July 19, 2024

Re: Corrections Response
Upstate Job #1651
Dhaliwal-Klar Residence
7024 SE 20th Street
Mercer Island, WA 98040

City of Mercer Island #2309-031

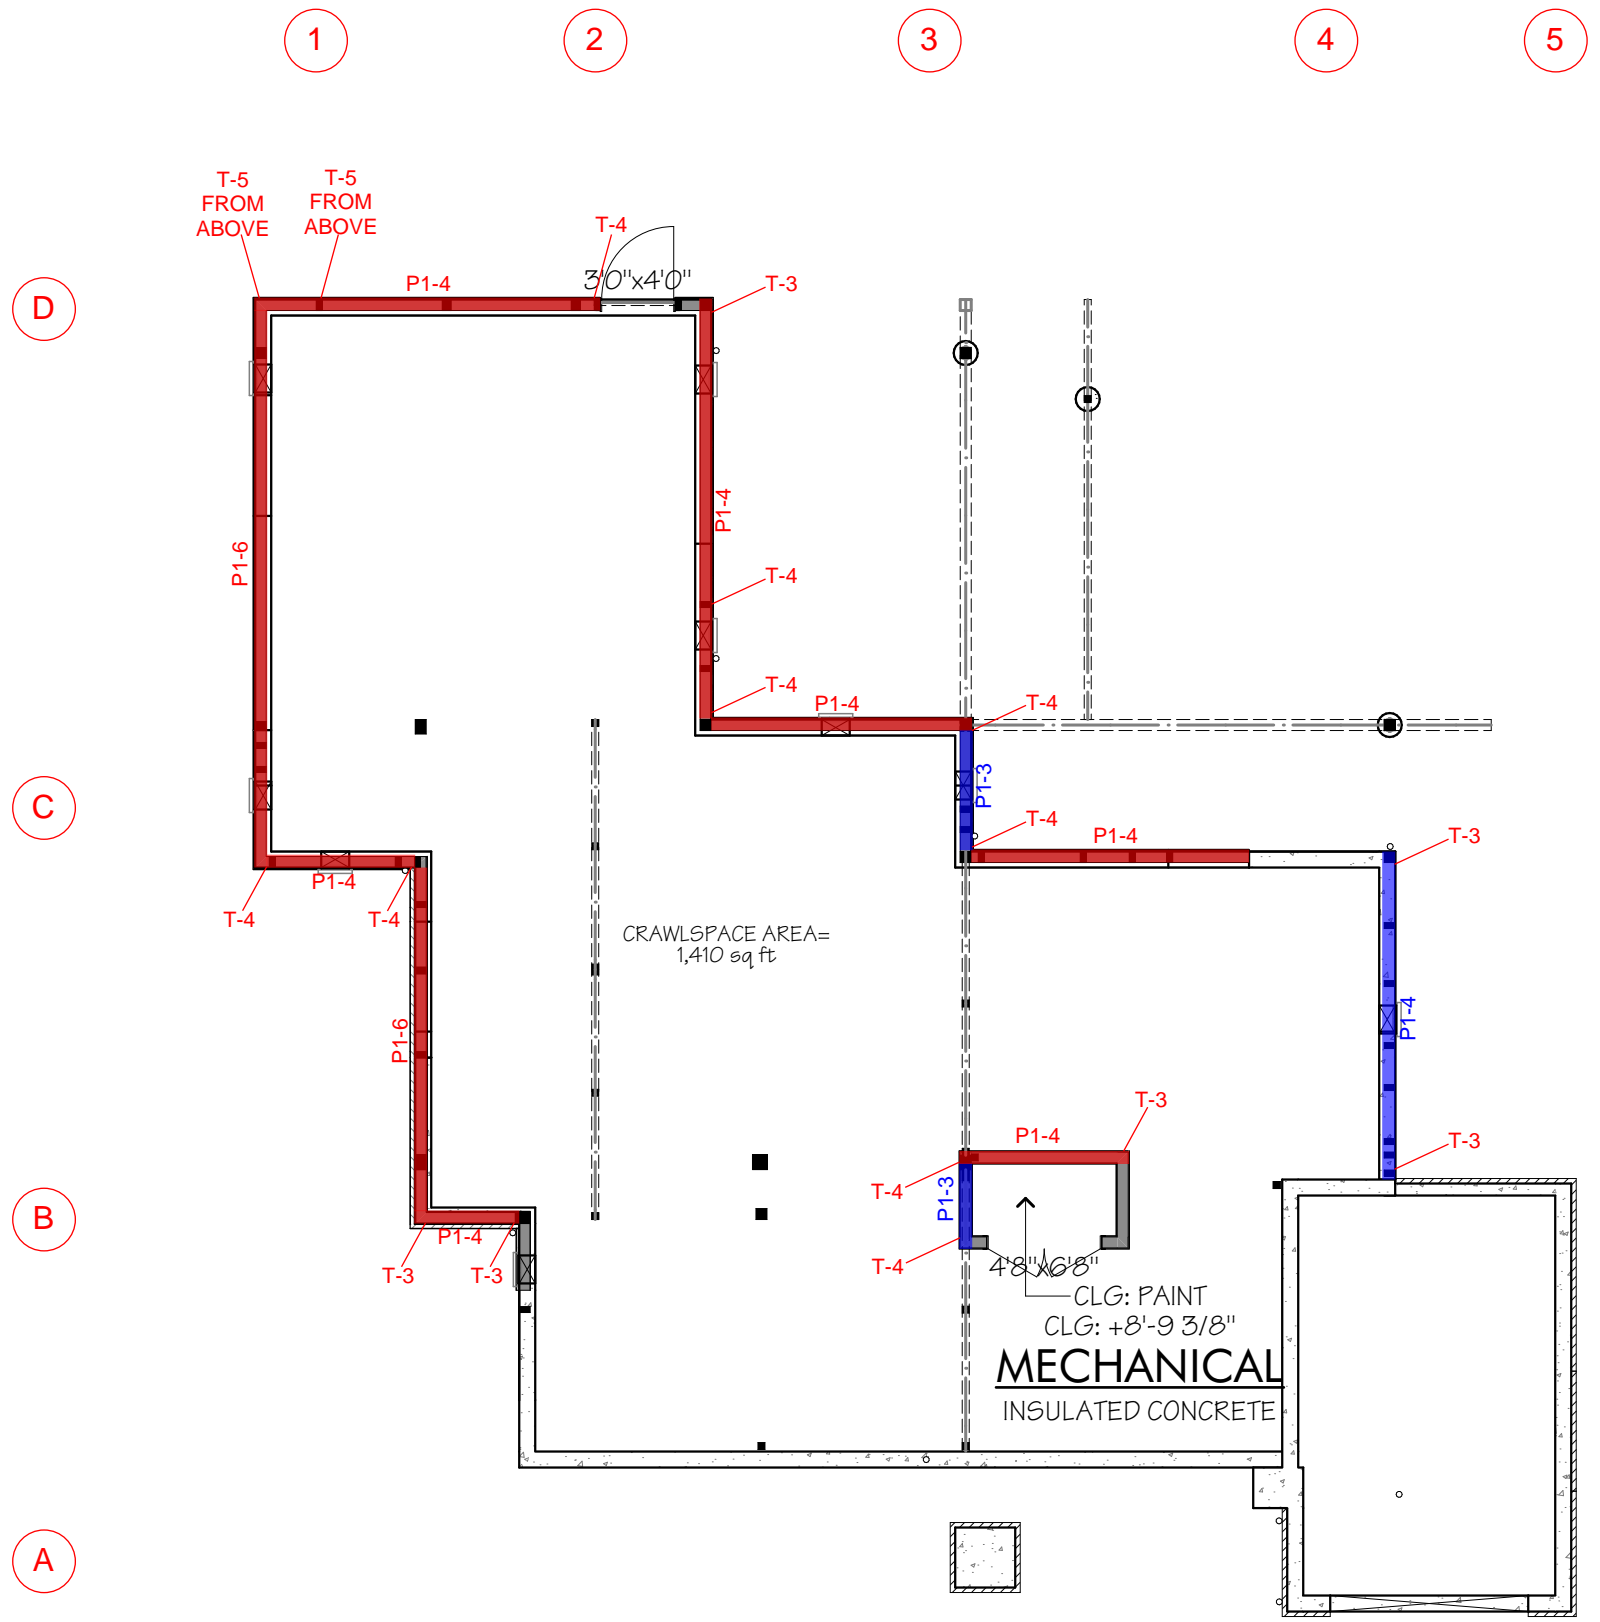
Comment: Calculations transition from a cantilevered wall to a top-restrained wall design above 8'. The detailing here is not accurate for the restrained wall (due to the position of bar) and no provision has been made for the load path of the restraint.

All foundation walls are meant to be cantilevered. The top-restrained calculations remaining within the last response was in error. See revised calculations.
